Mitigation Plan  
Banner Branch Mitigation Project  
Stokes County, North Carolina  
FINAL VERSION

NCDEQ DMS Project Identification # 100080  
NCDEQ DMS Contract # 7610 and # 7701  
Roanoke River Basin (Cataloging Unit 03010103)  
USACE Action ID Number: SAW-2018-01760  
Contracted Under RFP # 16-007405  
DWR Project # 20181154

Re: NCIRT Review and USACE Approval of the NCDMS Banner Branch Mitigation Site /  
Stokes Co./ SAW-2018-01760/ NCDMS Project # 100080

**SUBJECT:** Banner Branch Mitigation Site - NCIRT Comments during 30-day Mitigation Plan Review

SHEET NUMBER  
**23**

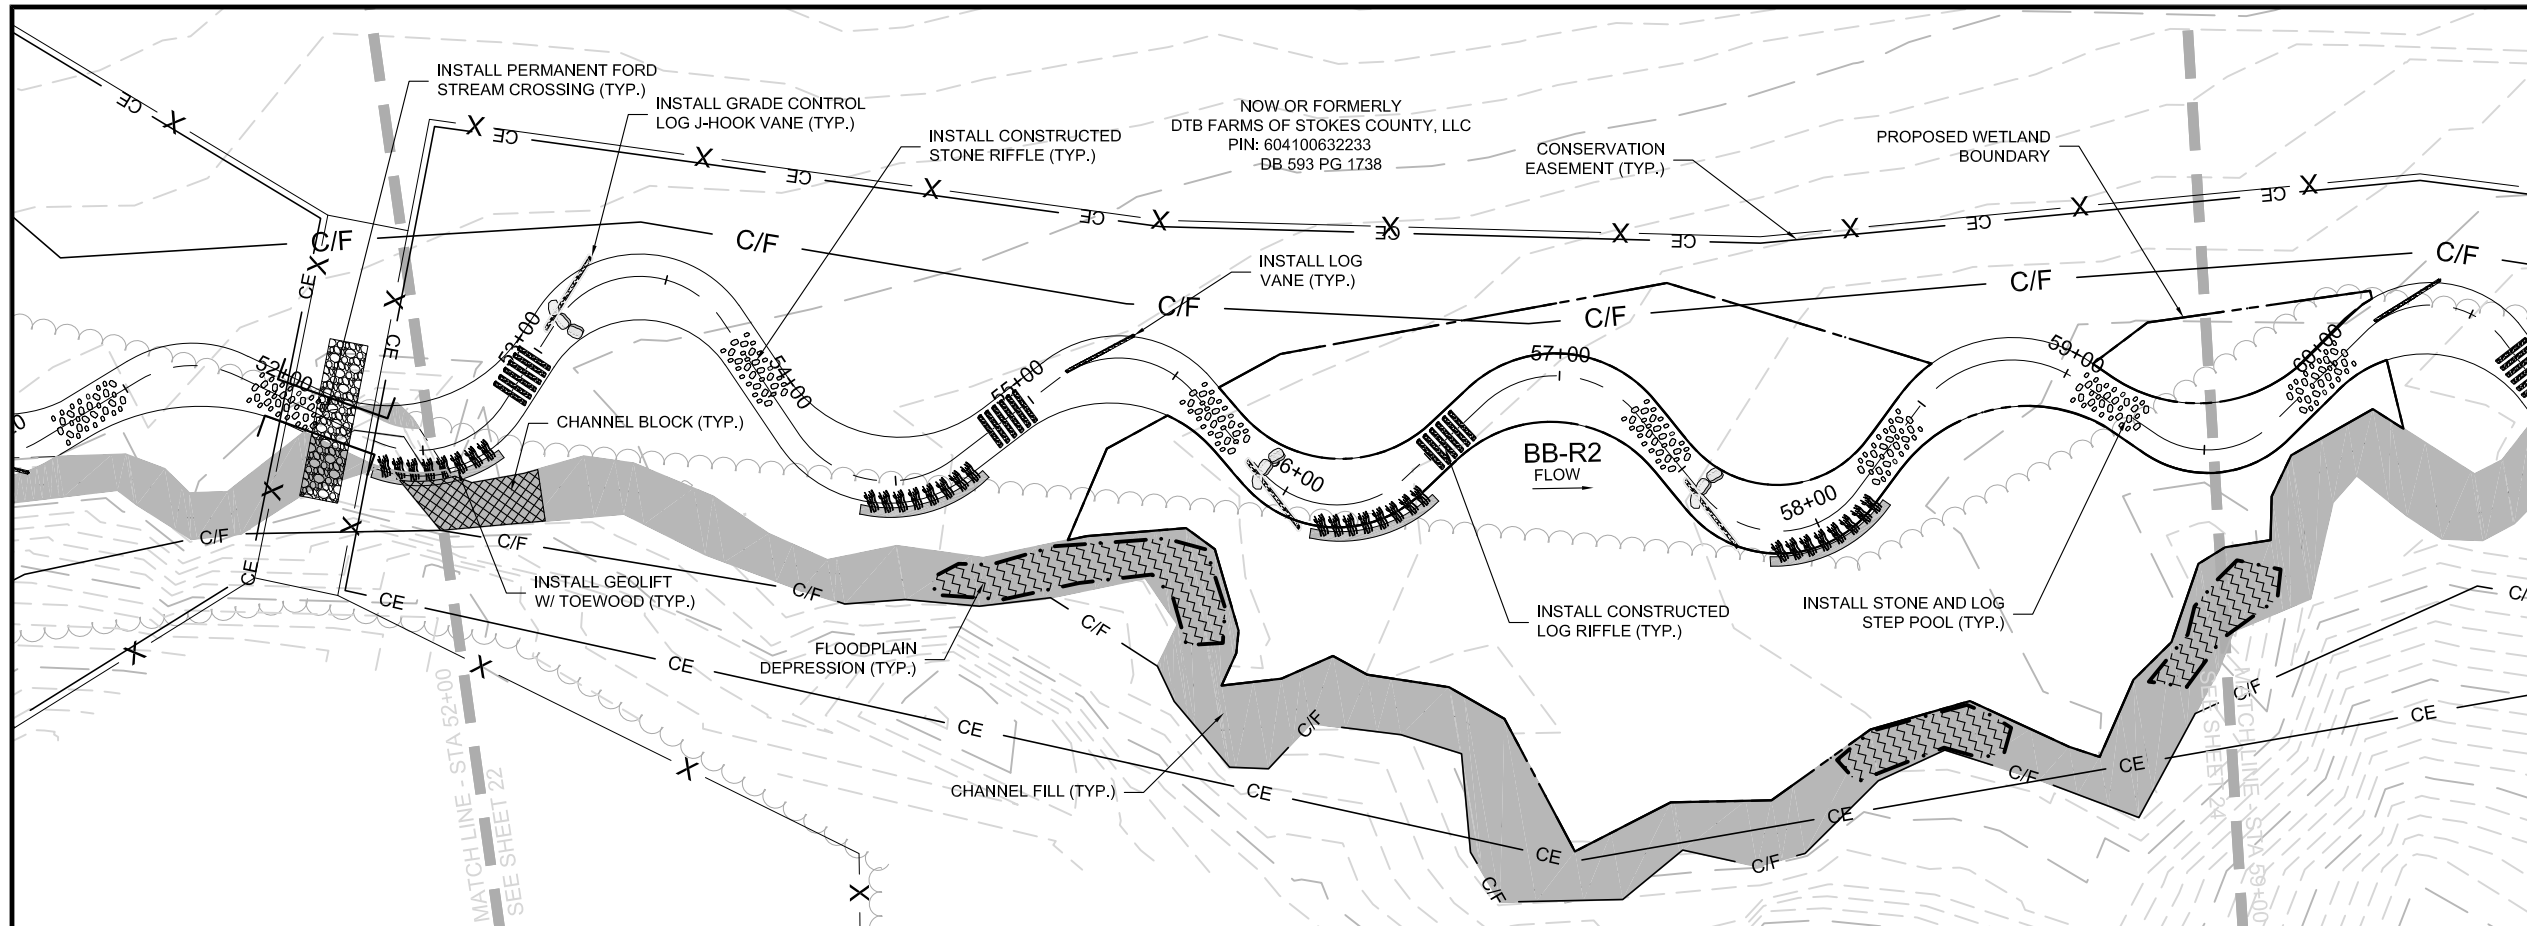
21. Sheet 3 – DWR recommends that benches be at least two times bankfull width for C type stream restoration.
22. Sheets 14, 23 & 33 – Please callout stream crossings/easement breaks on the profile views.

**22. Sheets 14, 23 & 33 – Please callout stream crossings/easement breaks on the profile views.** Response: Stream crossings/easement breaks have been noted in the profile views.
